**STAFF REPORT: SEPTEMBER 11, 2024 MEETING**

**APPLICATION NUMBER: HDC2024-00369**

**ADDRESS: 372 W. GRAND BLVD**

**SCOPE: REPLACE WOOD WINDOWS WITH ALUMINUM-CLAD WINDOWS**

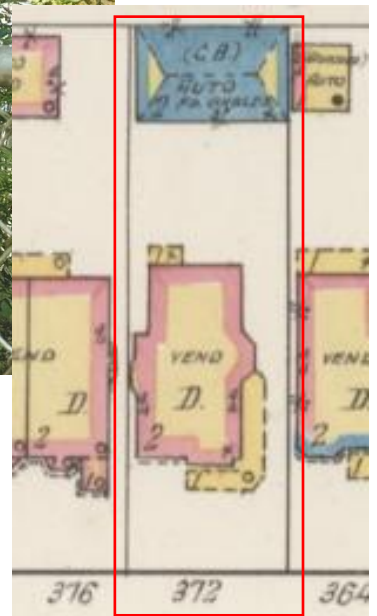
- Replace existing wood windows on the house.
